# SAN FRANCISCO PLANNING DEPARTMENT

## DRAFT Planning Commission Motion NO. M-XXXXX

*Hearing Date:* August 24, 2017  
*Case No.:* **2014-001272ENV**  
*Project Title:* **Pier 70 Mixed-Use District Project**  
*Zoning:* M-2 (Heavy Industrial) and P (Public)  
40-X and 65-X Height and Bulk Districts  
*Block/Lot:* Assessor's Block 4052/Lot 001, Block 4111/Lot 004  
Block 4120/Lot 002, and Block 4110/Lots 001 and 008A  
*Project Sponsor:* David Beaupre/Port of San Francisco  
[david.beaupre@sport.com](mailto:david.beaupre@sport.com), (415) 274-0539  
Kelly Pretzer/Forest City Development California, Inc.  
[KellyPretzer@forestcity.net](mailto:KellyPretzer@forestcity.net), (415) 593-4227  
*Staff Contact:* Melinda Hue – (415) 575-9041  
[melinda.hue@sfgov.org](mailto:melinda.hue@sfgov.org)

### ADOPTING FINDINGS RELATED TO THE CERTIFICATION OF A FINAL ENVIRONMENTAL IMPACT REPORT FOR THE PROPOSED PIER 70 MIXED-USE DISTRICT PROJECT.

(REVISED) FIGURE 4.P.1: SAMPLE LOCATIONS AND AREAS OF IDENTIFIED IMPACT

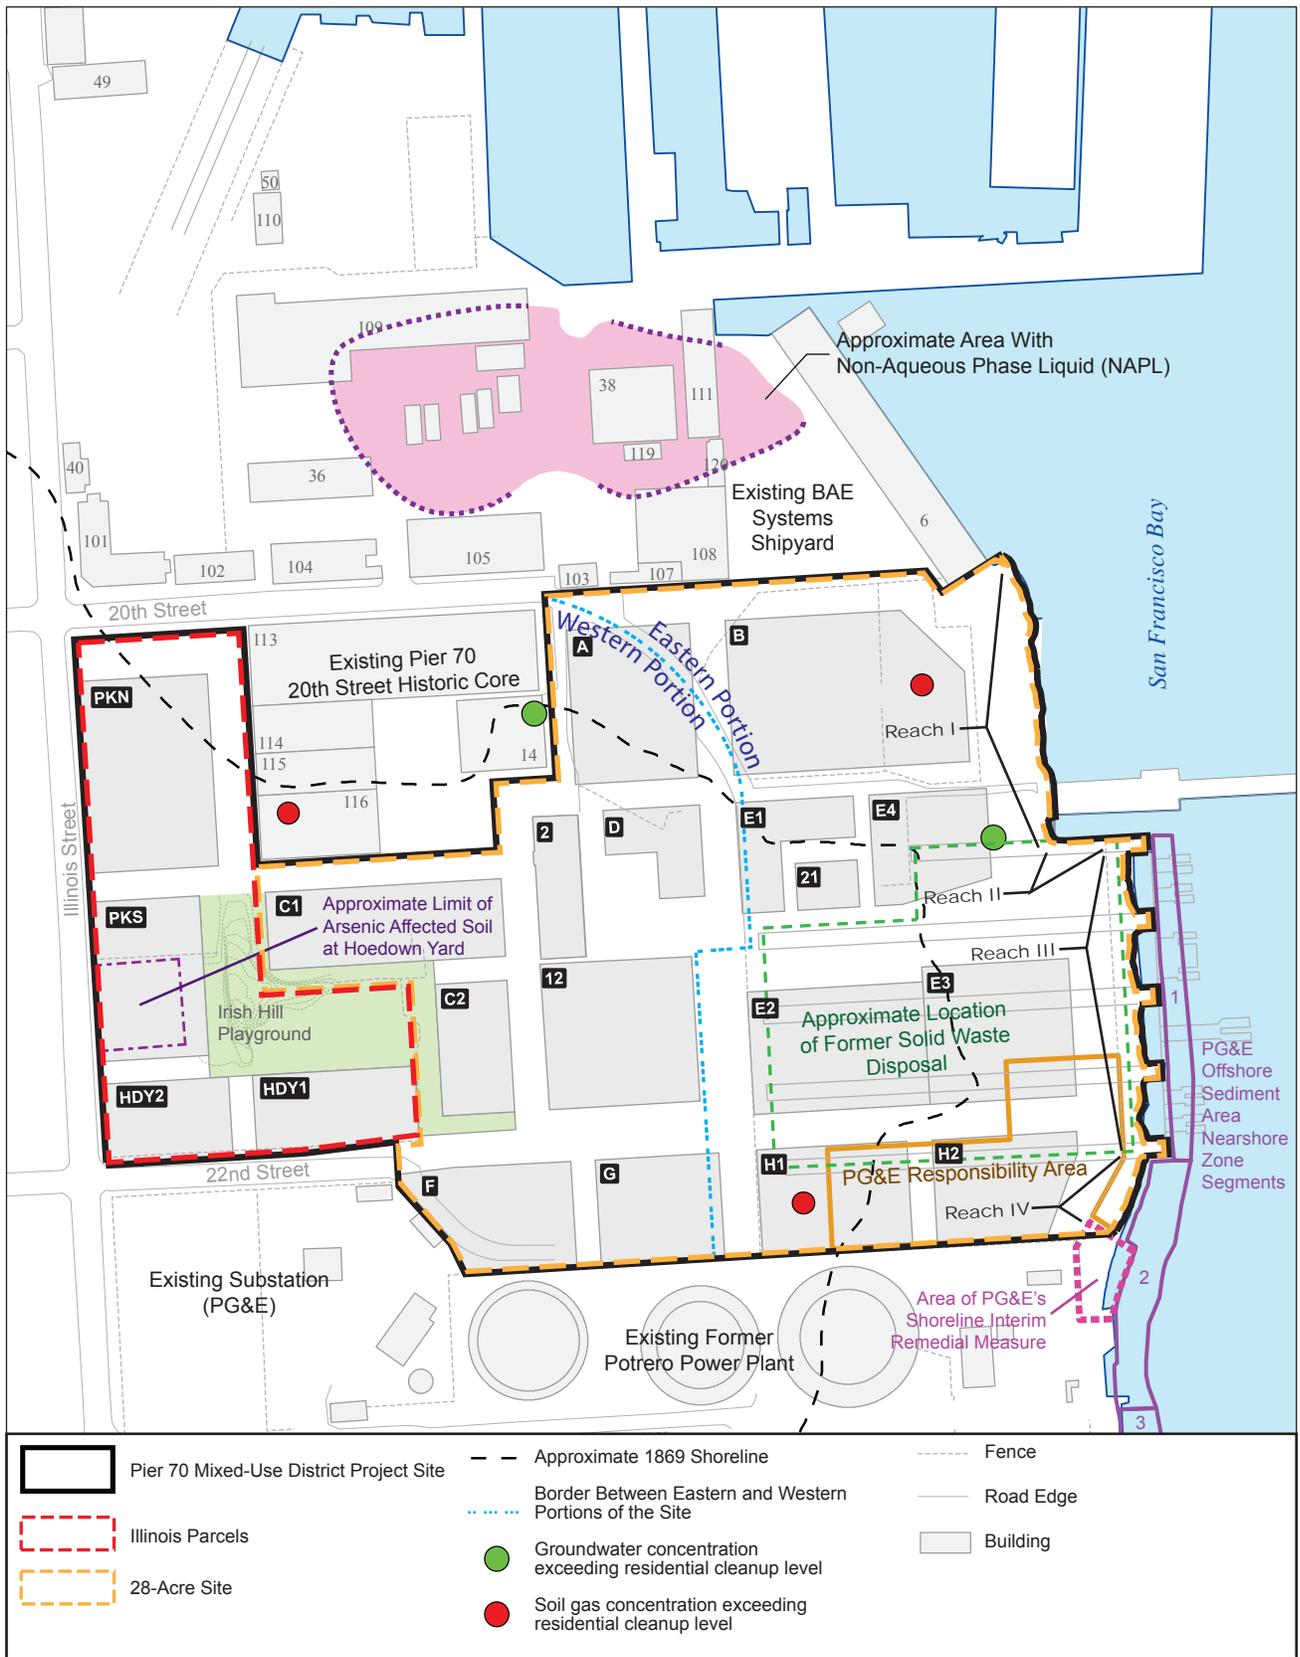
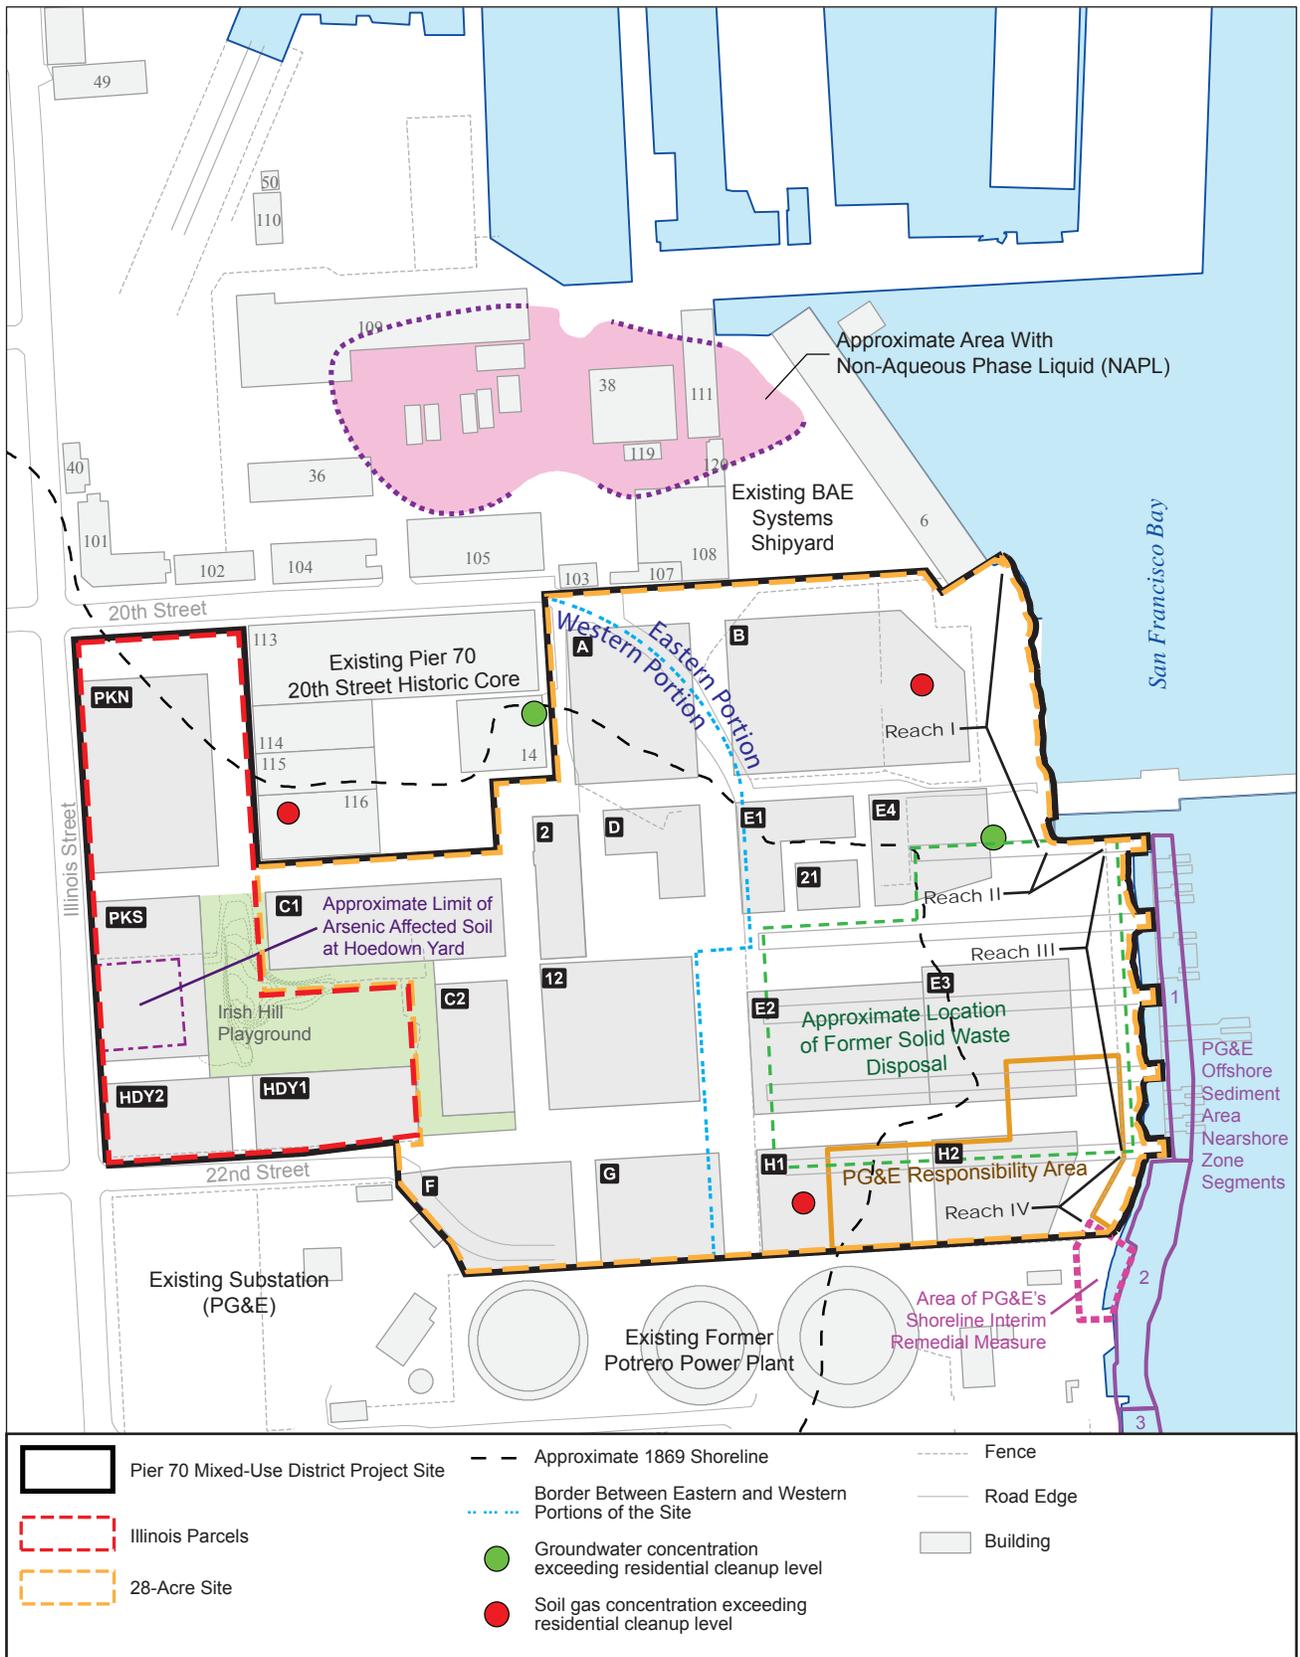
Figure 4.P.1: Sample Locations and Areas of Identified Impact, on EIR p. 4.P.3, has been revised to show the location of PG&E's Interim Remedial Measure and Reaches I through IV of the shoreline improvements proposed under the Pier 70 Mixed-Use District Project. The revised figure is shown on RTC p. 4.P.10.

Figure 4.P.1: Sample Locations and Areas of Identified Impact, on EIR p. 4.P.3, has been revised to show the location of the Interim Remedial Measure, and Reaches I through IV of the shoreline improvements proposed under the Pier 70 Mixed-Use District Project. The revised figure is shown on the following page.
